Access Compliance Report

Public Rights-of-Way

| Intersection ID: 5714 | Main Street: JOHN_KIRK_DR | Cross Street: UNIVERSITY_CITY_BV | Location: E |
| ADA ID: 7E7D26FDF17F | Ramp Type: Perp | Initial Pass/Fail: Fail | Overall Compliance: No |

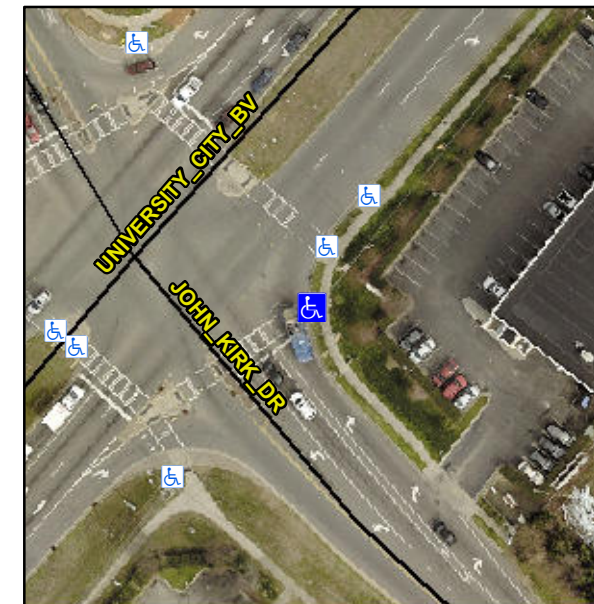
Not Found, R304.5.1, R304.2.2

| Compliance | Description | Data | Compliance | Description | Data |
|------------|-----------------------|-------|------------|-----------------------------|------|
| N/A | Ramp Length (in) | 59.0 | No | Ramp Slope (%) | 10.1 |
| No | Ramp Width (in) | 47.1 | Yes | Ramp XSlope (%) | 2.8 |

Remove & Replace Entire Ramp.
